CONSTRUCTION SUMMARY

Lindsay 2017 Developments Inc. / Sugarwood

Lot/Unit: 75 Phase/Building: 2 Model/Floor Plan: Silver Lake (3702) Elev B 3Bed 2.5Bath

SKETCH #1

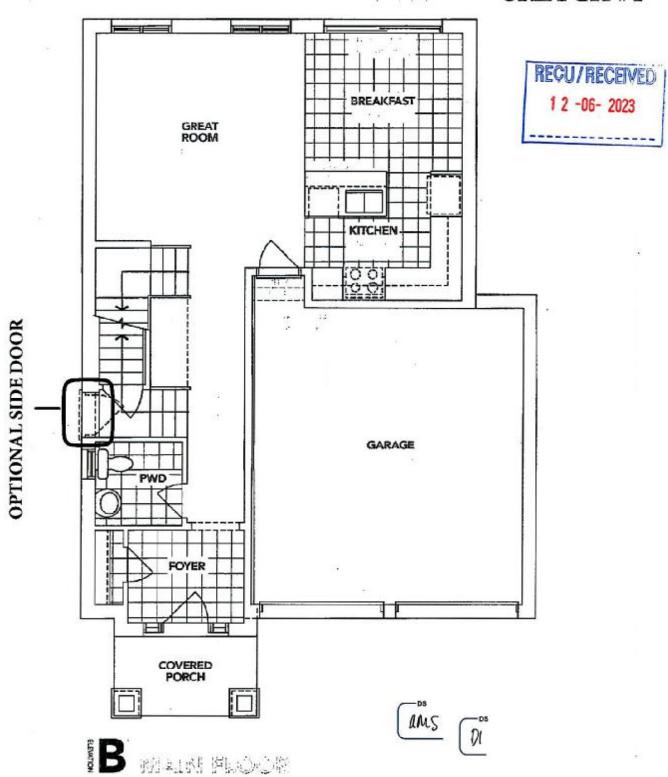
Inv. 6283	1 - TO SUPPLY AND INSTALL THE OPTIONAL SIDE DOOR SEE SKETCH #1	
Line 79207	Note:	
6Jun23 / 9Jun23		
Inv. 6283	5 - TO SUPPLY AND INSTALL UPGRADED BASMENT WINDOWS ("36X24") IN LIEU OF THE STANDARD SEE SKETCH #2	
Line 79208	Note:	
6Jun23 / 9Jun23

SKETCH #2

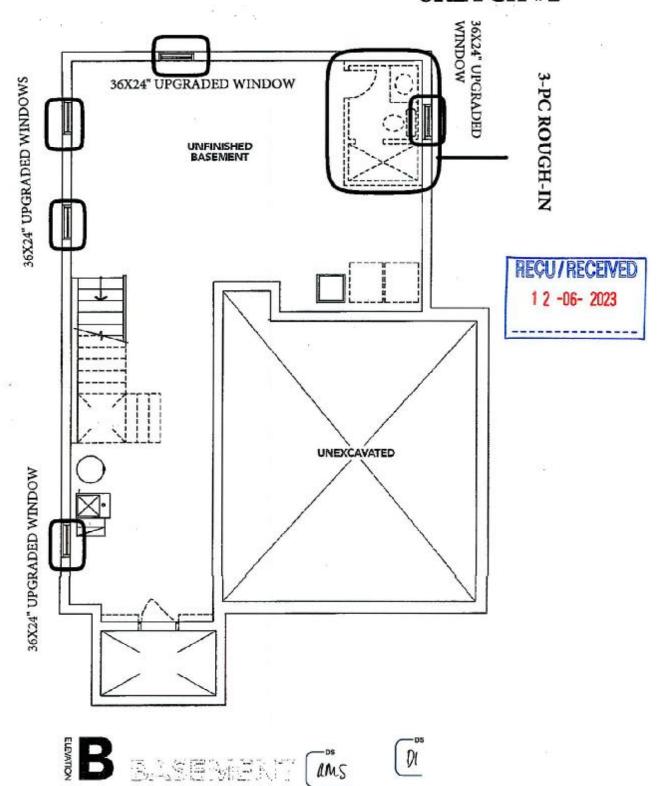
Inv. 6283	1 - TO SUPPLY AND INSTALL THE OPTIONAL 3-PC ROUGH-IN SEE SKETCH #2	
Line 79209	Note:	
6Jun23 / 9Jun23
